RE: Williamsburg Landing Nursing and Living Facility
(Now Woodhaven at Williamsburg)
Plan No. SP-50-96
BMP ID Codes: CC 011 (BMP 1 Dry Pond)
AES Project No. 8162

Re: Williamsburg Landing (County Plan SP-50-96)
Nursing & Assisted Living Facility
Record Drawings and Construction Certification

The Environmental Division has reviewed a record drawing set, consisting of Sheets C001, C005 and C010, as submitted to our office on June 7th for the above referenced project.

DAM - CROSS SECTION
DRY POND #1

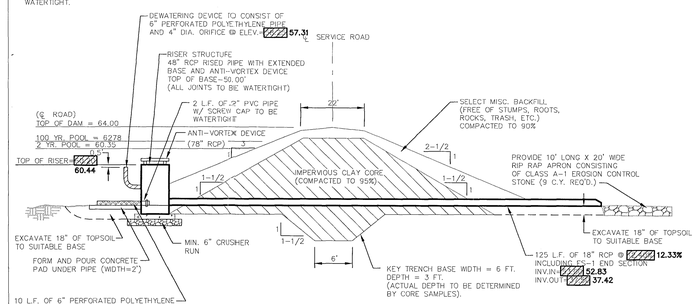
4. Dry Pond # 1. The as-built invert-in and invert-out elevation for the pond outlet barrel would result in an as-built pond barrel slope different from that of the approved design plan. Make this correction on the detail on record drawing Sheet C010 as necessary.

SECTION A-A
PRESSURE TREATED WOOD DRY DETENTION STRUCTURE

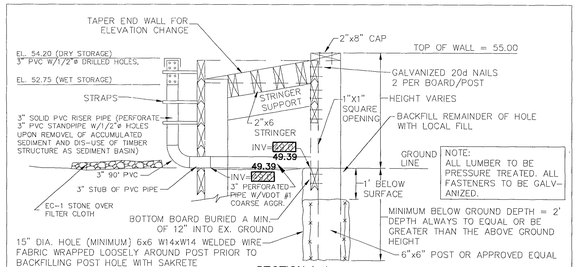
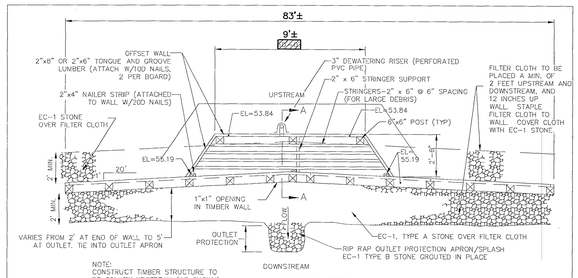
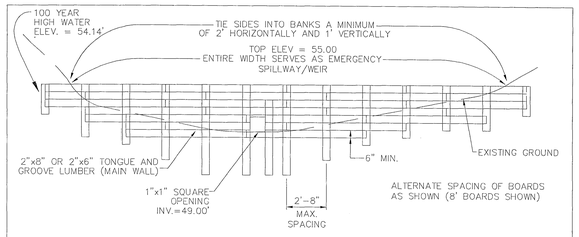
11. Dry Pond # 2. The 3 inch diameter PVC riser needs perforated in accordance with the approved plan. Perforations were only visible on the bottom portion of the riser. Also, perforations that are present in the bottom half of the riser were clogged with organic material and need cleaned.
